Report of
Dam Safety Assessment of Coal Combustion
Surface Impoundments

Kentucky Utilities,
a wholly owned subsidiary of
LG&E and KU Energy LLC

Green River Station, Central City, KY

April 2011

SECTION B-B'
CRITICAL SLOPE CROSS SECTION

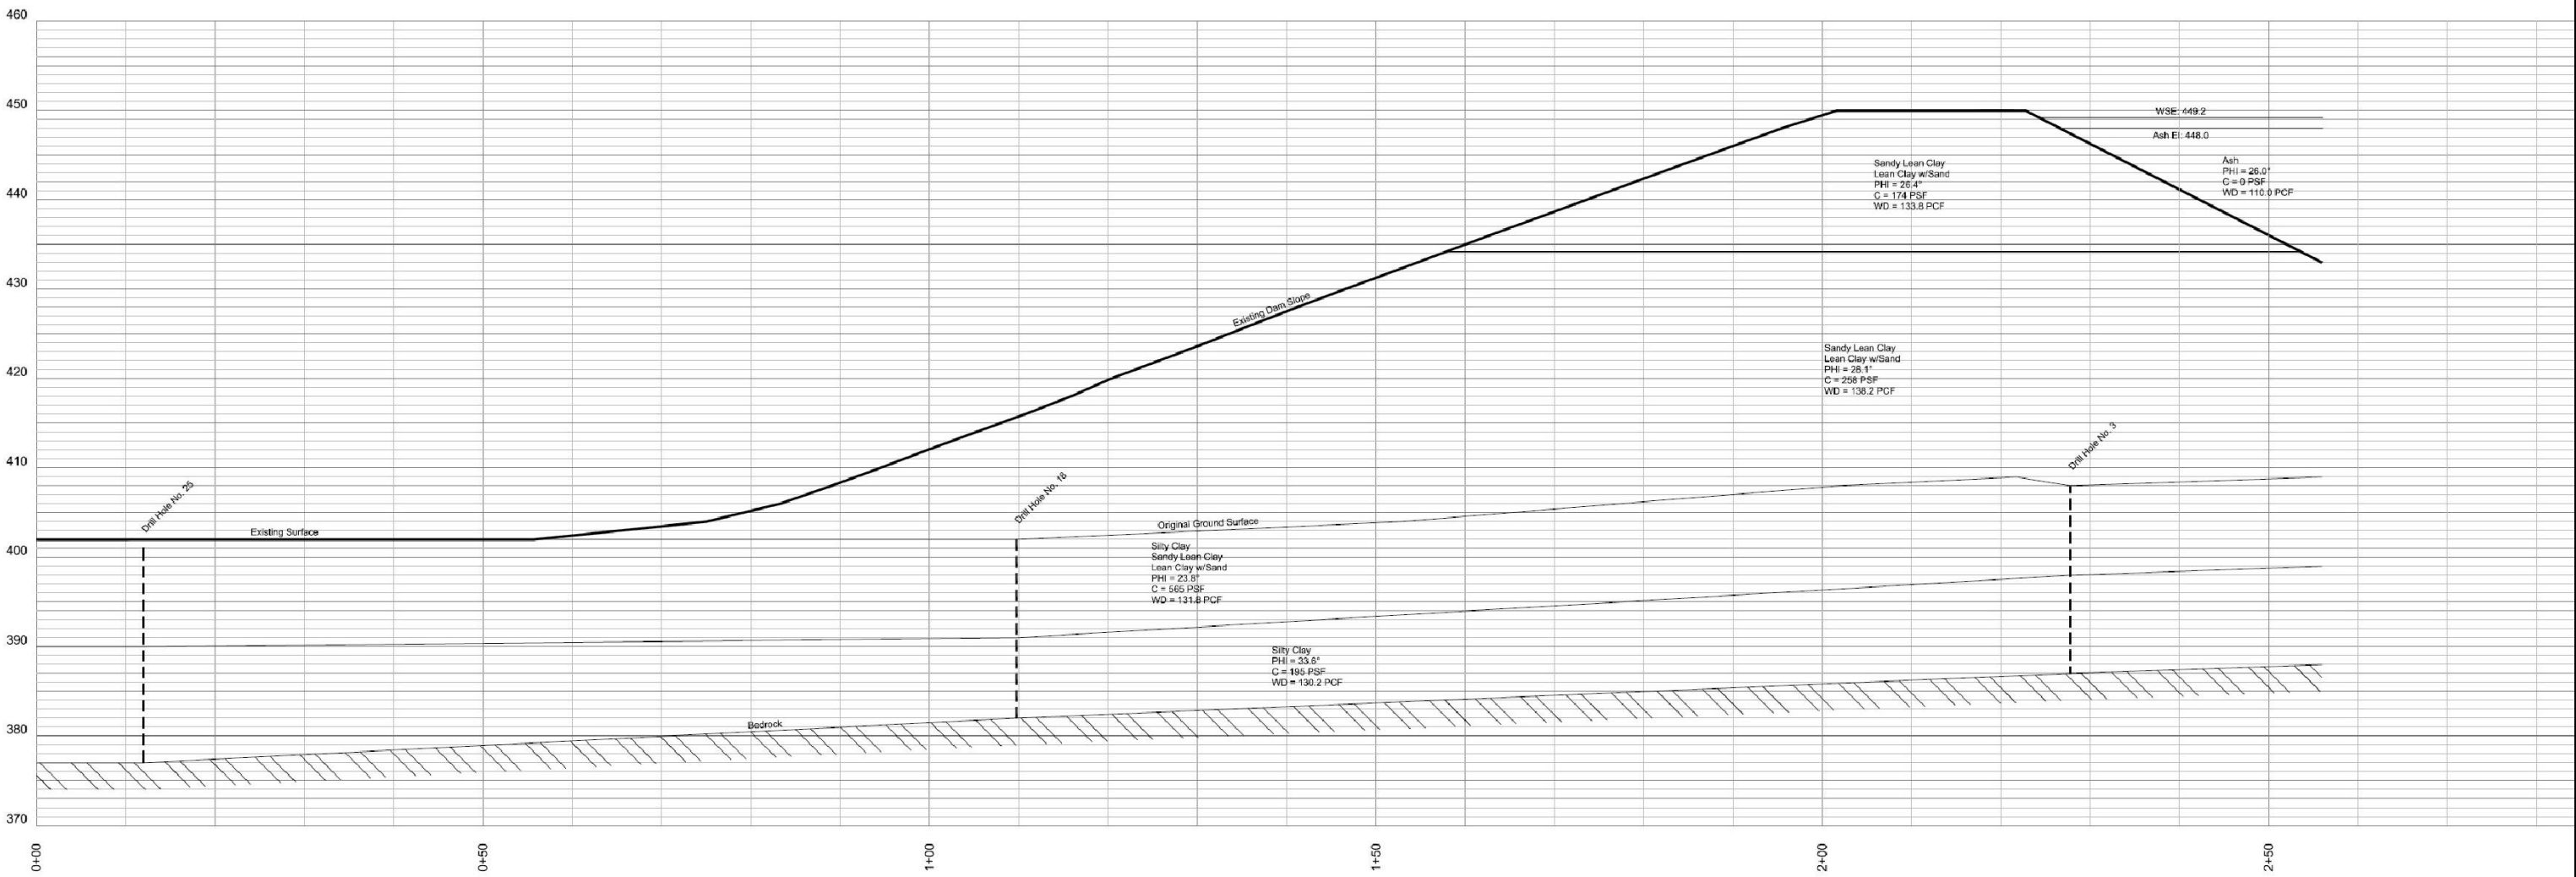
The analysis should consider all critical stages over the life of the pond including pond full conditions. These conditions would need to be determined in conjunction with the hydraulic recommendations above. The hydraulic analysis should provide a phreatic surface through the embankment. A rapid-drawdown should be performed for the A-A' section in case the pond

would need to be lowered in response to a problem. The friction angle value used for the CCW in the analysis appears high for ash material. Typical ash friction values are 28 degrees for compacted, 24 degrees for loosely compacted, and 11 degrees for uncompacted material. Consideration should be given for lowering strength values to account for inconsistencies within the fill or foundation materials. Consideration should also be given to allow water levels in the piezometers to develop and stabilize. The analyses presented appear limited to a circular surface; different types of failure surfaces should be analyzed and optimized.

In the opinion of the assessing professional engineer, the analyses should be revised in accordance with these recommendations. The analysis should consider all critical stages over the life of the pond including pond full conditions. These conditions would need to be determined in conjunction with the hydrologic and hydraulic recommendations above. The hydrologic and hydraulic analysis will provide maximum water levels in the pond and a phreatic surface through the embankment.
